Origination Form

Proposed Revisions to a Standard Plans Index

Originator:	Stepp, Richard	Index Number:	536-001
Date:	6/01/2025	Sheet Number(s):	1,2,3,7,8,9,13,15,16
E-mail:	richard.stepp@dot.state.fl.us	Index Title:	Guardrail

SHEET 2 of 25

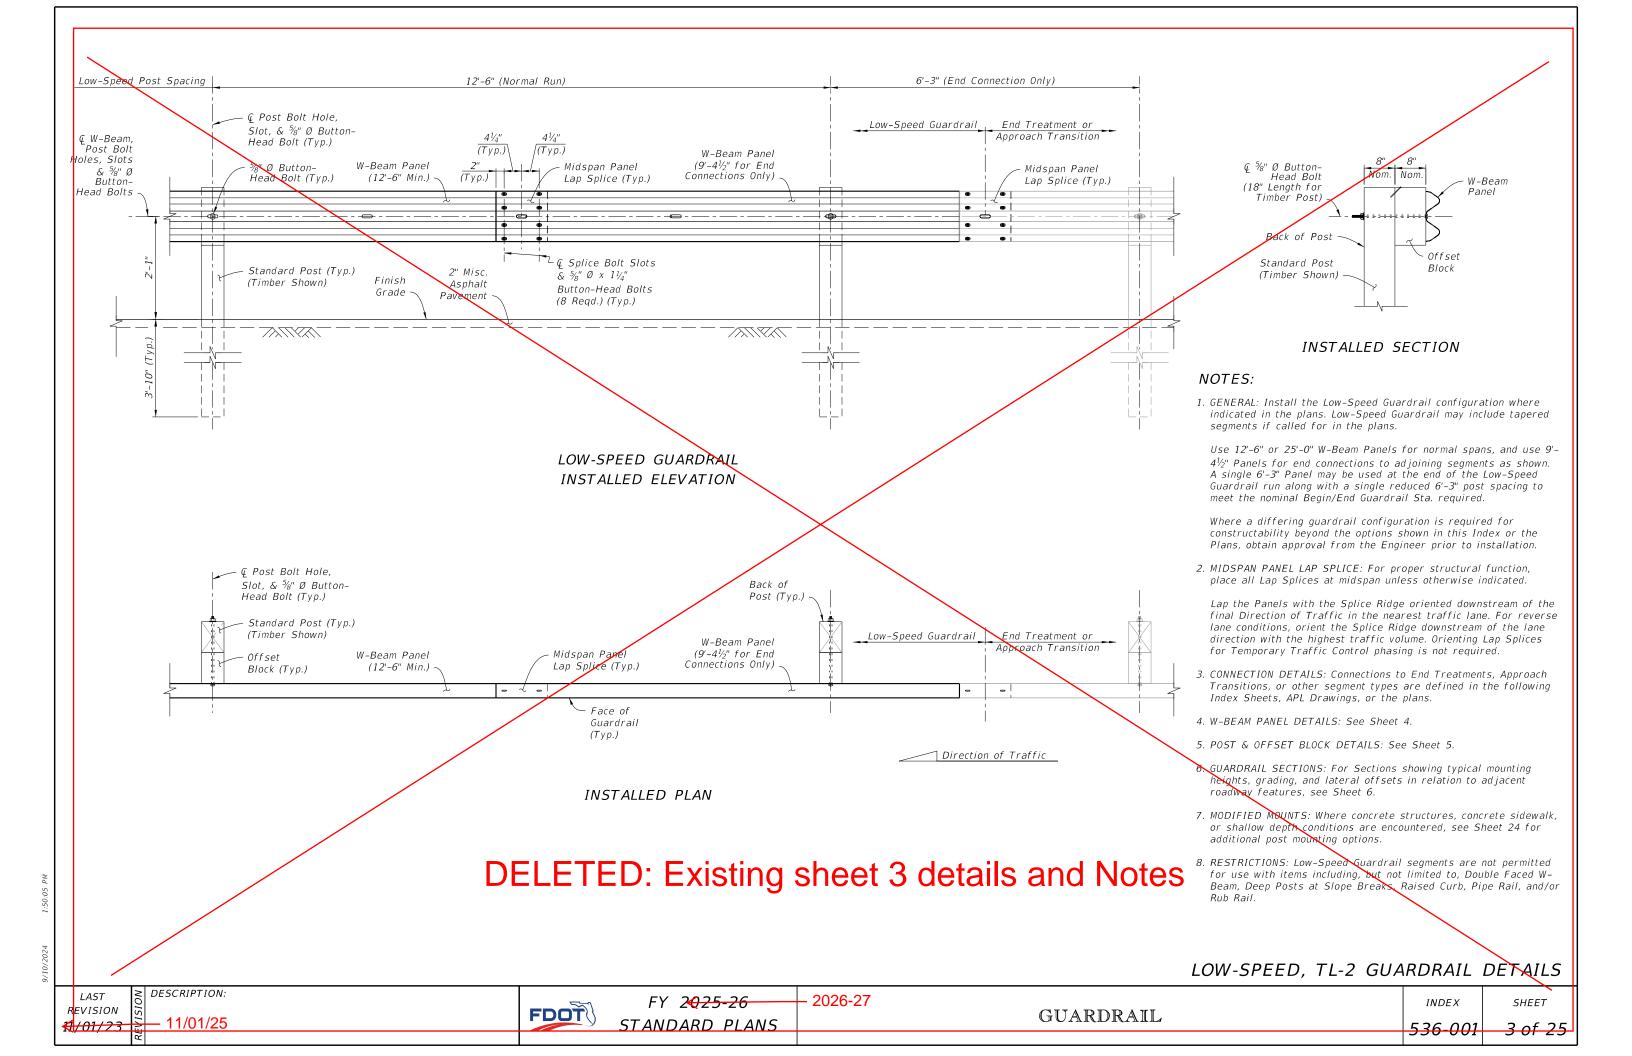
Sheet 2: Sheet title - Deleted "TL-3"

DELETED: TL-3 specific langauge

END TREATMENT - APPROACH TERMINAL GEOMETRY - PARALLEL

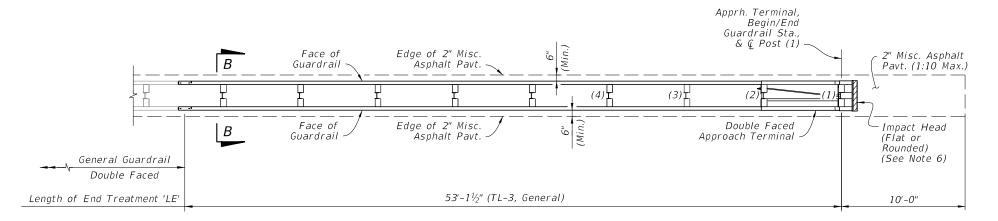
Sheet 7 & 8: Approach Terminal Assembly details - Added text explaining design speeds for the TL-2 and TL-3 options

APPROACH TRANSITION CONNECTION TO RIGID BARRIER - LOW-SPEED, TL-2

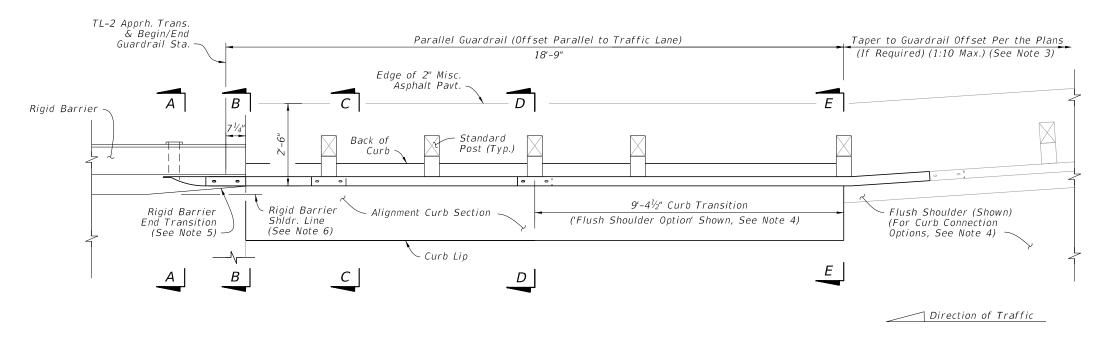
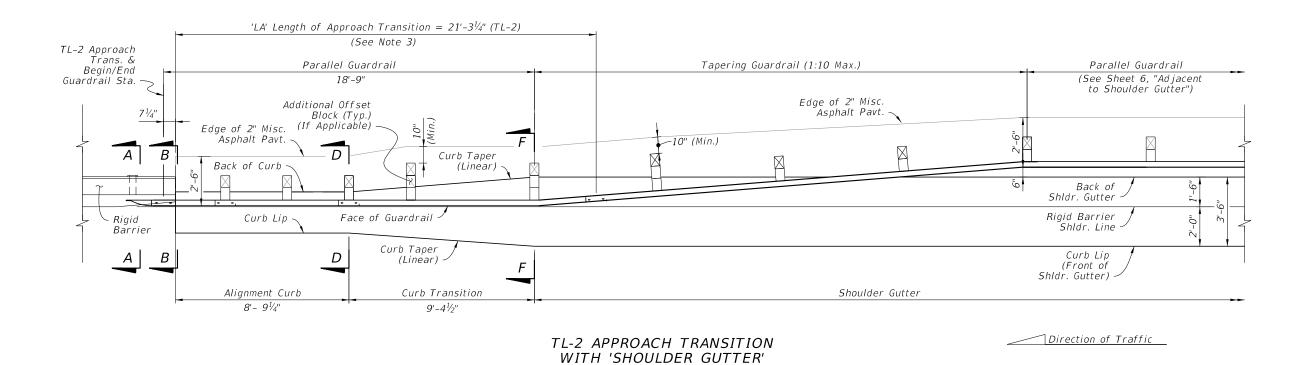
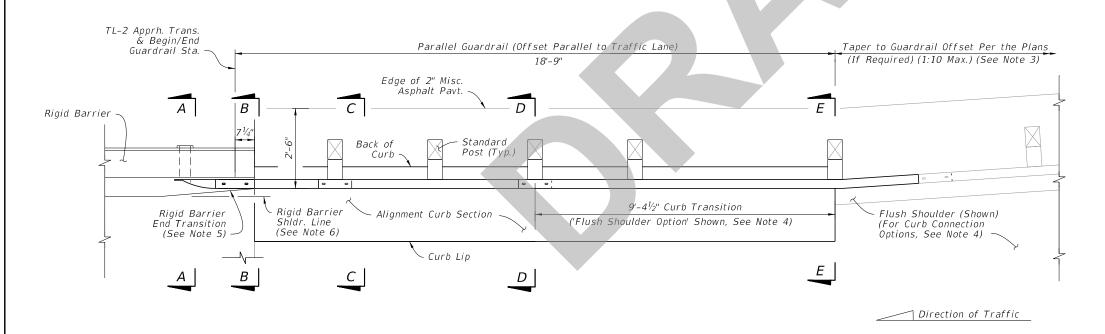
Sheet 15: Installed Elevation detail - Replaced "Low Speed" with "General" guardrail label; Note 1 - Specified "TL-

2" Approach Transition; Sheet title - Added applicable design speed

1. INSTALLATION: Construct the TL-2 Approach Transition segment only where indicated in the plans. For example Layouts showing the Approach Transition's fit among other guardrail segments, see Sheet 19.

> APPROACH TRANSITION CONNECTION TO RIGID BARRIER LOW-SPEED, TL-2 OPTION (DESIGN SPEED ≤ 45 MPH)

-APPROACH TRANSITION CONNECTION TO RIGID BARRIER - LOW-SPEED, TL-2 CURB CONNECTIONS

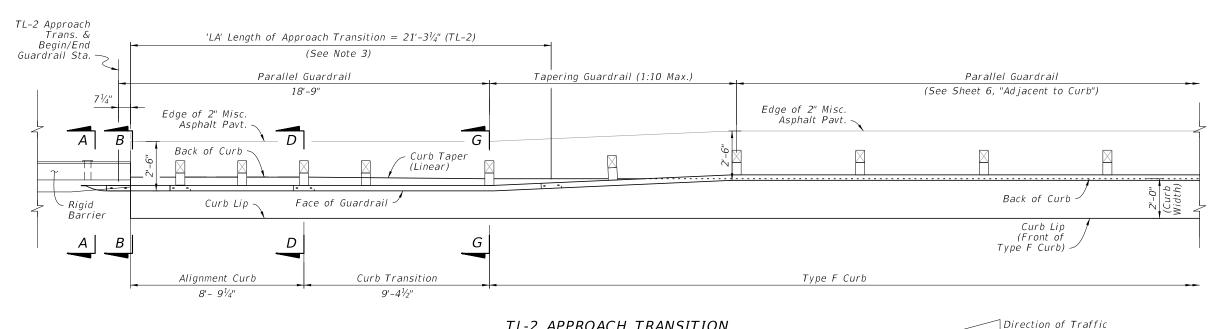
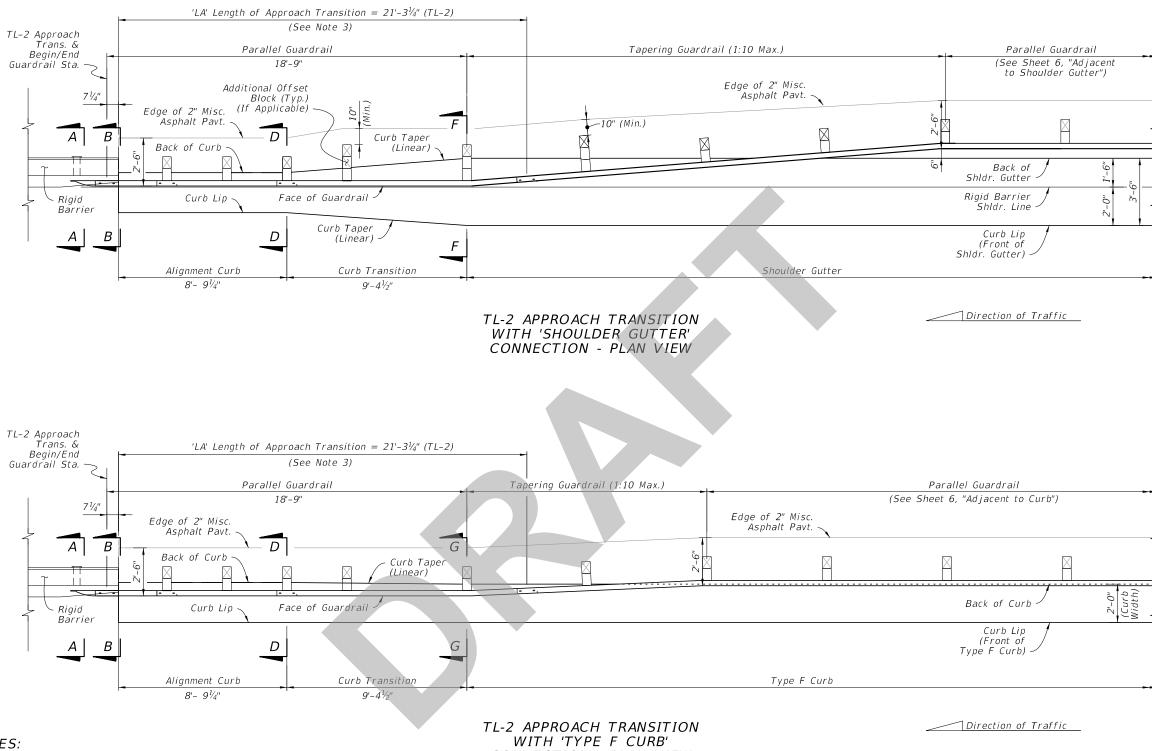
Sheet 16: Sheet title - Added applicable design speed

APPROACH TRANSITION CONNECTION TO RIGID BARRIER LOW-SPEED, TL-2 OPTION (DESIGN SPEED ≤ 45 MPH), CURB CONNECTIONS

CONNECTION TO EXISTING 27" HEIGHT GUARDRAIL

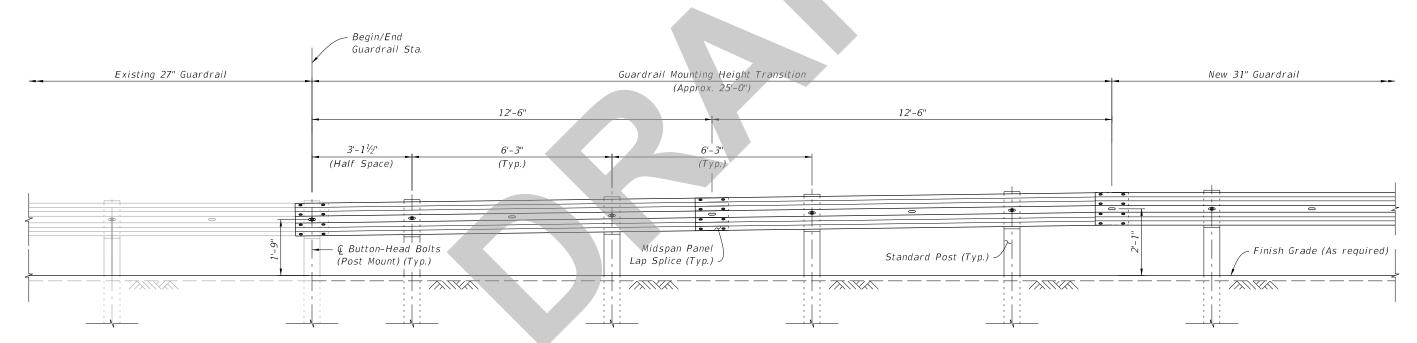
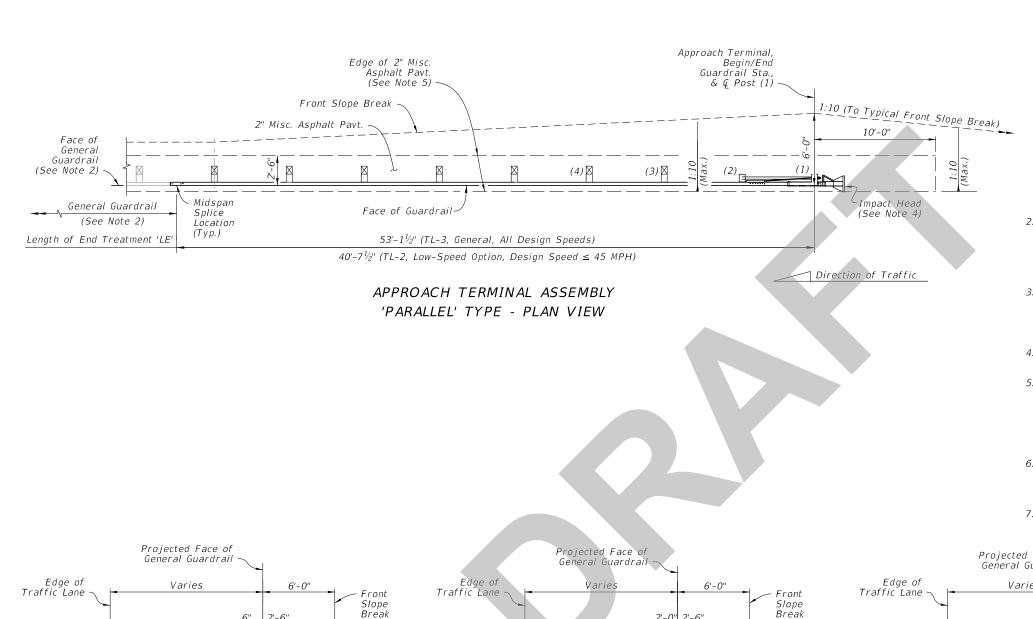
Sheet 3: Deleted previous sheet for Low-Speed TL-2 Guardrail. Replaced with new sheet for "Connection to Existing 27" Height Guardrail" details.

NEW SHEET 3: CONNECTION TO EXISTING 27" HEIGHT GUARDRAIL

ADDED: Option 1 and Option 2 details for transition to existing guardrail

ADDED: Notes

- 1. Height transitions must occur outside of End Treatment and Approach Transition segments.
- Consider post location alignment needs when selecting option.
 Either option may be used unless a specific option number is called for in the plans.

APPROACH TRANSITION CONNECTION TO RIGID BARRIER - GENERAL, TL-3

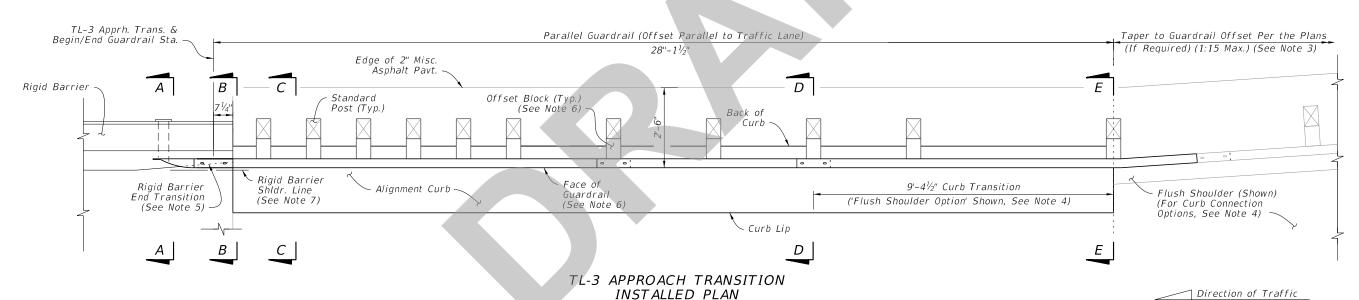
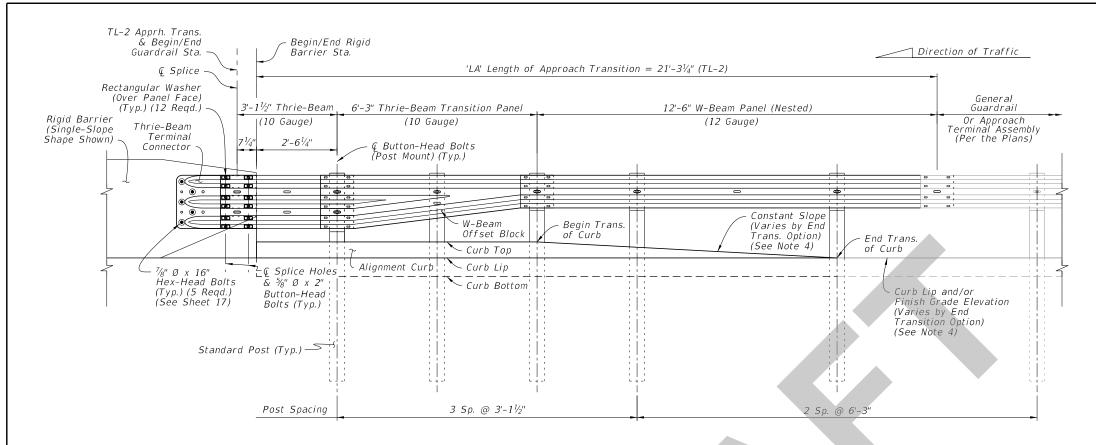
Sheet 13: Note 1 - Specified "TL-3" Approach Transition

1. INSTALLATION: Construct the TL-3 Approach Transition_segment where indicated in the plans. For example Layouts showing the Approach Transition's fit among other guardrail segments, see Sheet 19.
